## ADDENDUM NO. 2

Issue Date: March 21, 2022

Project Name: IRC-1639: 69<sup>th</sup> Street From 66<sup>th</sup> Avenue to SR5/US-1, Resurfacing (SCOP)

Bid Number: 2022028

SHEET  
NO.  
38A

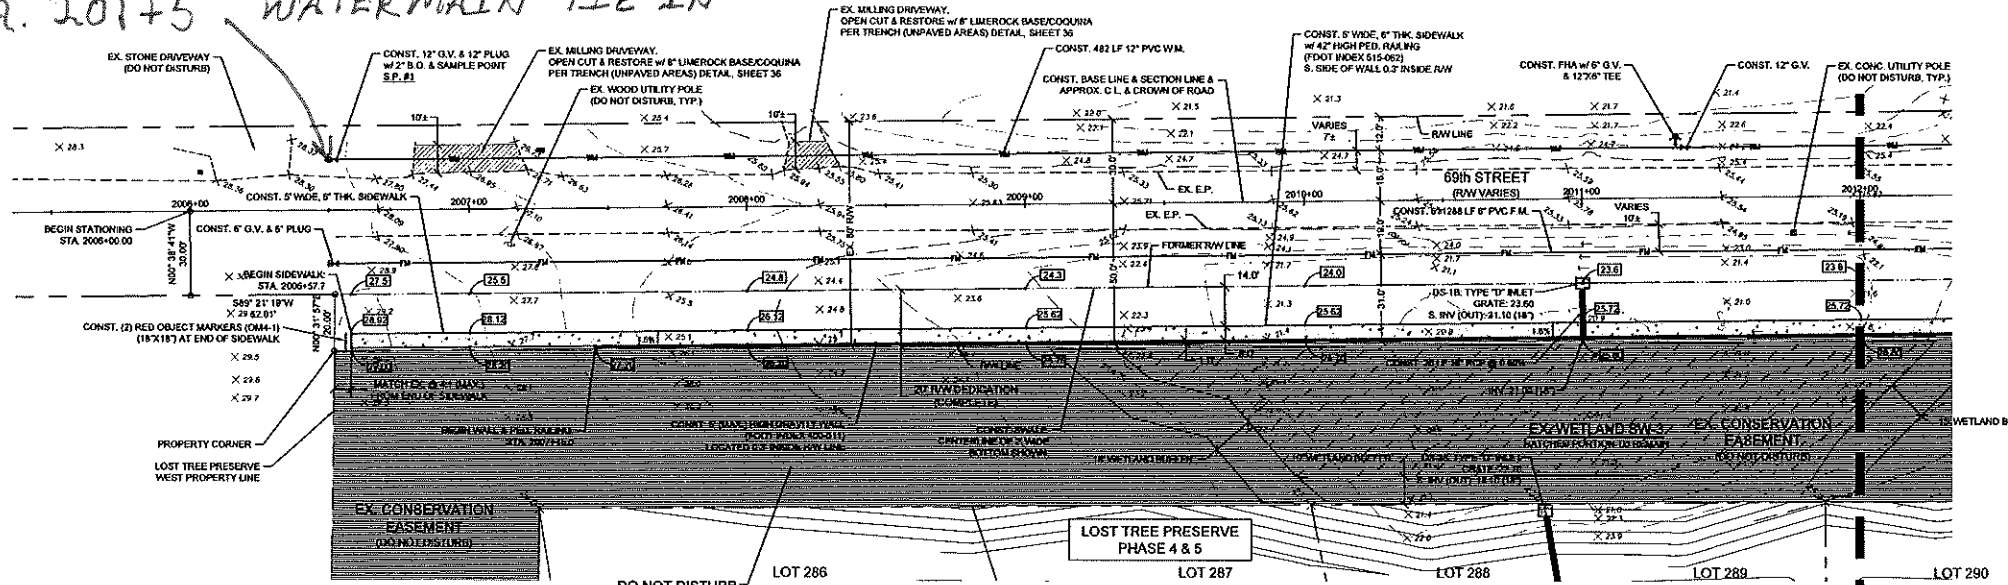
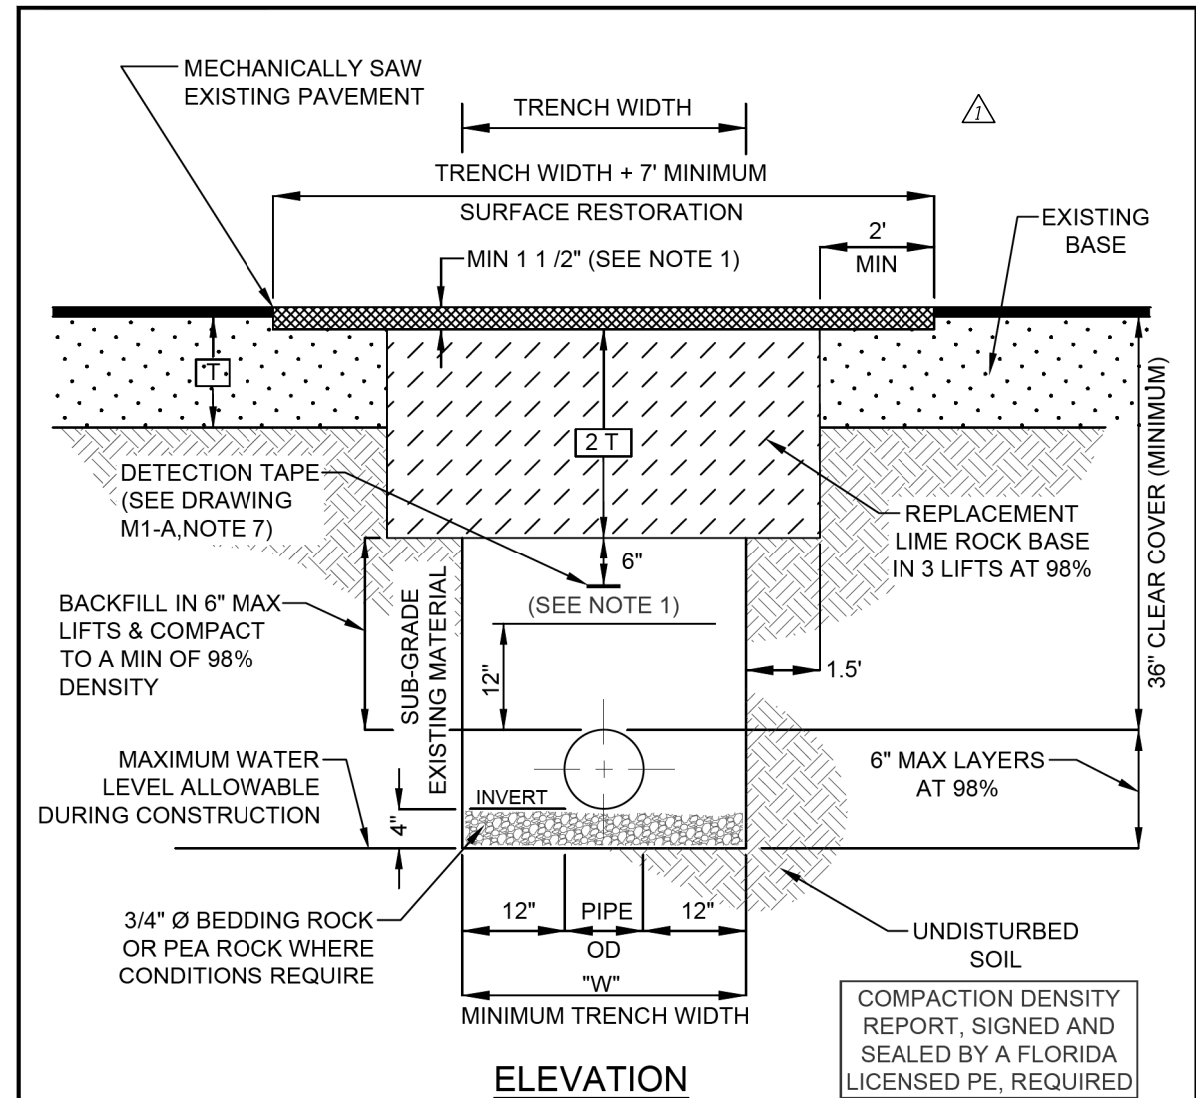
**Replace Plan Sheet 38A, Miscellaneous Detail with Plan Sheet 38A, Miscellaneous Detail – Addendum 2**

18. The Detail M-2 referenced on the plans for restoration of pavement over piping is missing?  
**Plan Sheet-38A, Miscellaneous Detail with Detail M-2 is attached with Addendum 2.**

- A question was asked about pipe crossing detail M-2 and how it wasn't included in the plans. Brian Good stated that detail will be sent out in an addendum. He stated the pipe should be installed first and per detail M-2. Tim Rose and Zach Rose questioned the order in which the work is to take place when installing drainage and James Ennis stated for clarification that the roadway can be broken, the drainage or utility installed, the trench be restored per detail M-2 and the FDR process be performed throughout. If the Contractor chose to perform the drainage work first, the trench would need to be restored per detail M-2 and it would include temporary asphalt.
